Access Compliance Report

Public Rights-of-Way

(Curb Ramps)

Intersection ID: 10958	Main Street: CAMP_GREENE_ST	Cross Street: TUCKASEEGEE_RD	Location: NW
ADA ID: 40FB8C9C4089	Ramp Type: PerpDiag	Initial Pass/Fail: Fail	Overall Compliance: No
Severity Score: 25			
Codes/Mitigation Info/Possible Solution		Field Measurements/Component Compliance

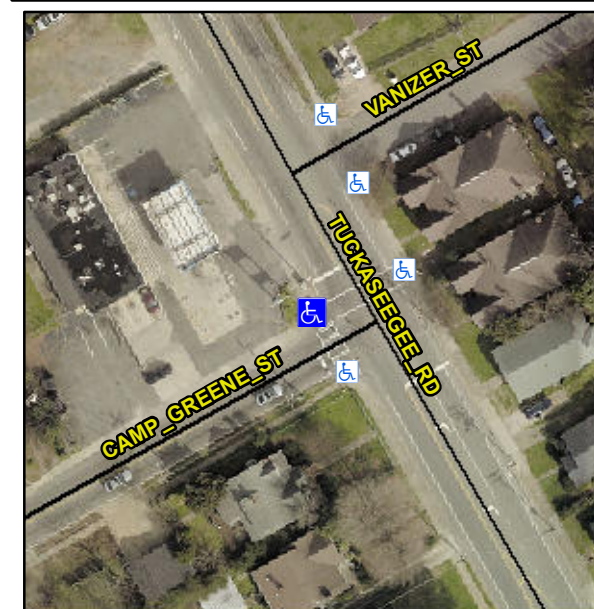
Not Found, R304.2.2

Compliance	Description	Data	Compliance	Description	Data
N/A	Ramp Length (in)	45.0	No	Ramp Slope (%)	12.0
Yes	Ramp Width (in)	48.0	Yes	Ramp XSlope (%)	0.4
N/A	Flare Type LT	N/A	N/A	Flare Type RT	N/A
N/A	Flare Slope LT (%)	N/A	N/A	Flare Slope RT (%)	N/A
N/A	Flare Traversable LT?	N/A	N/A	Flare Traversable RT?	N/A
N/A	Landing Length (in)	N/A	N/A	DWS Provided?	N/A
N/A	Landing Width (in)	N/A	N/A	DWS Contrast?	N/A
N/A	Landing Slope (%)	N/A	N/A	DWS Length (in)	N/A
N/A	Landing X Slope (%)	N/A	N/A	DWS Full Width?	N/A
N/A	Landing Curb? (Y/N)	N/A	N/A	DWS Offset (in)	N/A
N/A	Shared Landing?	N/A			
N/A	Gutter Ponding?	N/A	N/A	Gutter Slope (%)	N/A
N/A	Gutter Lip Ht (in)	N/A	N/A	Gutter X Slope (%)	N/A
N/A	Painted X Walk1?	Yes	N/A	Painted X Walk2?	Yes
	X Walk 1 Direction	To S		X Walk 2 Direction	To E
N/A	X Walk 1 Width (in)	109.0	N/A	X Walk 2 Width (in)	113.0
	X Walk 1 Slope (%)	1.0		X Walk 2 Slope (%)	5.6
	X Walk 1 X Slope (%)	2.2		X Walk 2 X Slope (%)	1.0

Remove & Replace Curb Ramp With Two New Directional Ramps or Equivalent.
